Town of Damariscotta
Planning Board Meeting Agenda
Tuesday, January 3, 2023 – 6:00PM
Hybrid Meeting: Town Office & via Zoom

AGENDA ITEM #3A
Meeting of January 3, 2023

Site Plan & Conditional Use Applications – Main Street Grocery
5 Coastal Market Drive – Main Street Grocery
PID #2205

Site Plan Amendment – Damariscotta Information Bureau
276 Main Street – Damariscotta Region Chamber of Commerce
PID #2207

DAMARISCOTTA CHAMBER OF COMMERCE
 SCHEMATIC UTILITY CONNECTION PLAN
 JANUARY 3, 2022
 PROJ. NO. 2020-457
 SK1

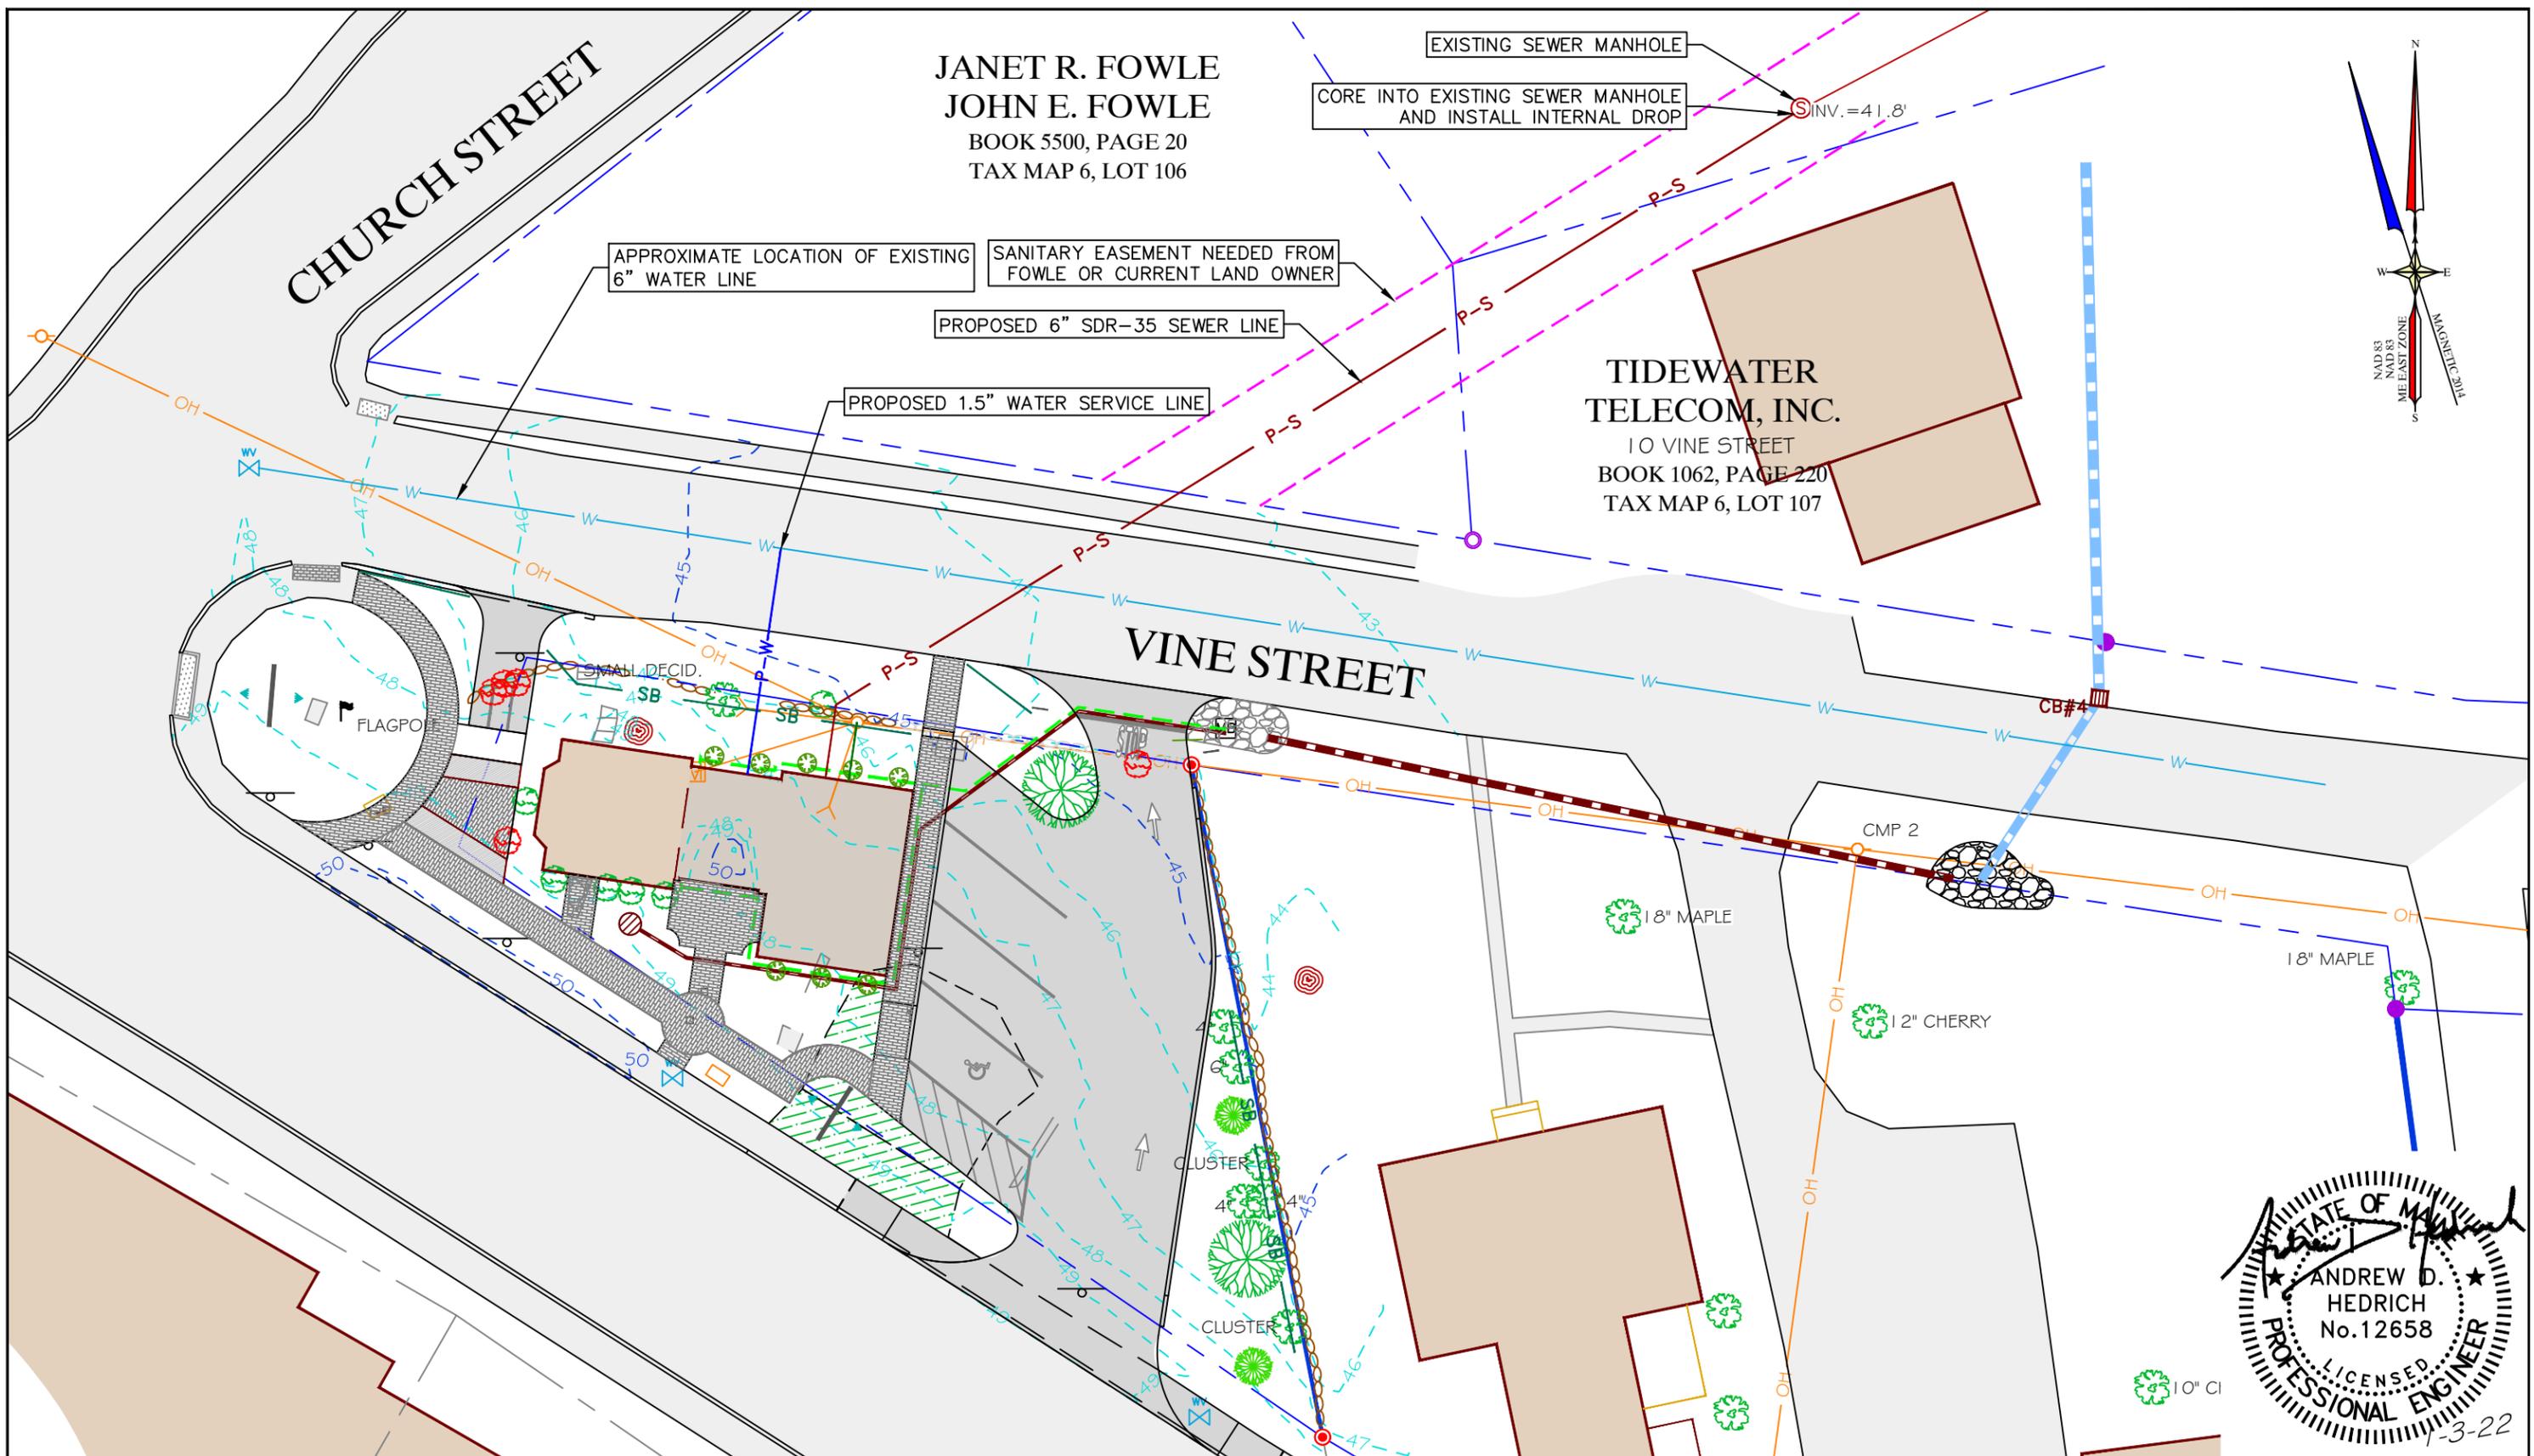
Thus, the applicants have asked for a waiver of this section in order to allow them to install a holding tank instead. The plan has been updated to show the area where the holding tank will be installed. Condition #4 requires that the Town's Plumbing Inspector (in this case, the Code Enforcement Officer) review the Subsurface Wastewater Disposal System Application to ensure compliance with the State's Subsurface Wastewater Disposal Rules.

4. The applicant shall secure a Subsurface Wastewater Disposal System permit from the Local Plumbing Inspector (the Code Enforcement Officer) prior to installing the holding tank. The Plumbing Inspector shall verify compliance with the State's Subsurface Wastewater Disposal Rules.	Code Officer	Prior to Installation of Holding Tank

Figure 1

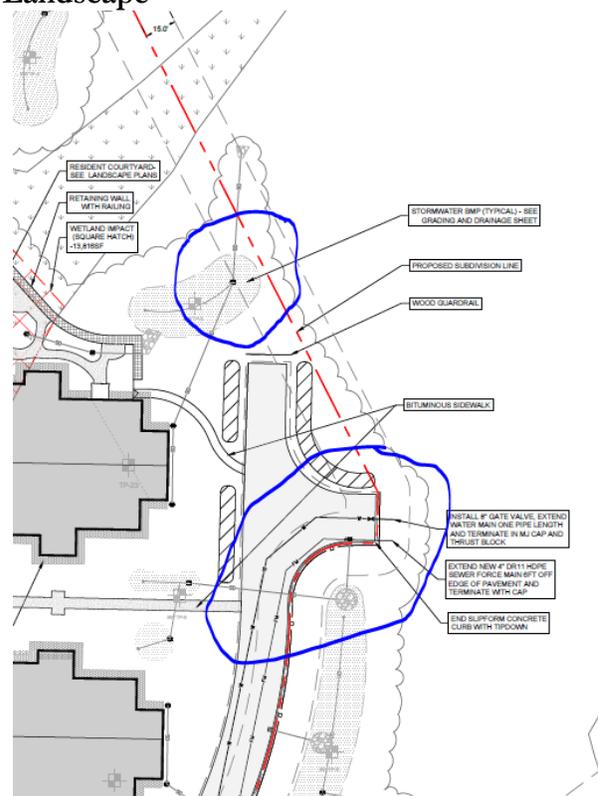
The bufferyard is the area at the perimeter of the property encompassing the Town's building setback requirements and the existing or planted vegetation, fencing, walls or berms located within the area. Per the standards outlined in this section, the only development permitted within the bufferyard is required landscaping and fencing, landscape lighting, essential utilities that cannot be located outside of the buffer because of site constraints, passive stormwater filtration areas, and points of ingress and egress as authorized by the Planning Board. Within the bufferyard, the applicants are proposing to locate the fire access drive. Additionally, the corner of a stormwater filtration area is located within the buffer yard. See Figure 1. As noted, these are exempt and thus, in staff's view, this standard has been met.

The applicants have indicated that the building has been sited in such a way as to preserve the landscape and existing topography of the site to the maximum extent practical. The building is centrally located to allow for natural vegetation to be retained in the buffer yards of the property. Additionally, a landscape plan has been submitted which shows approximately 150 new tree plantings, intended to shield the new development from abutting properties and from public streets.

Photo renderings of the proposed building and site have been provided by the applicants in a packet of supplemental materials dated November 23, 2022. The landscaping plan is further described in item #24 below.

Figure 1

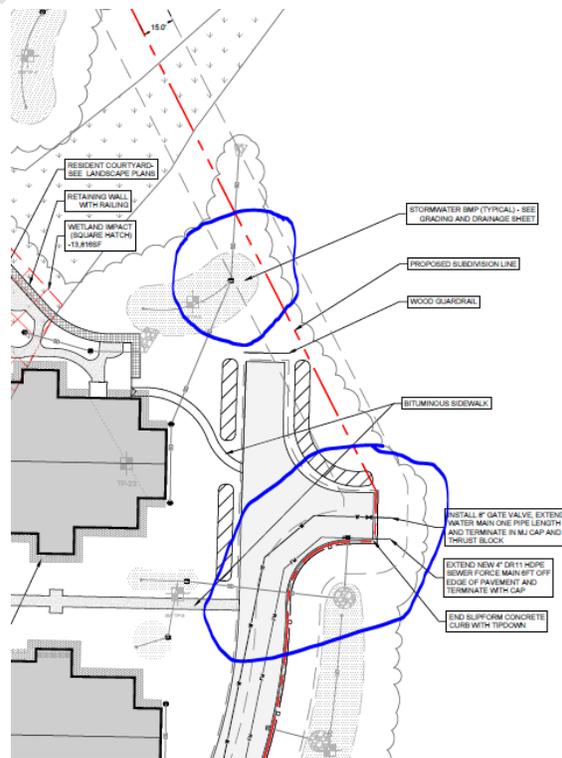
The bufferyard is the area at the perimeter of the property encompassing the Town's building setback requirements and the existing or planted vegetation, fencing, walls or berms located within the area. Per the standards outlined in this section, the only development permitted within the bufferyard is required landscaping and fencing, landscape lighting, essential utilities that cannot be located outside of the buffer because of site constraints, passive stormwater filtration areas, and points of ingress and egress as authorized by the Planning Board. Within the bufferyard, the applicants are proposing to locate the fire access drive. Additionally, the corner of a stormwater filtration area is located within the buffer

yard. See Figure 1. As noted, these are exempt and thus, in staff's view, this standard has been met.
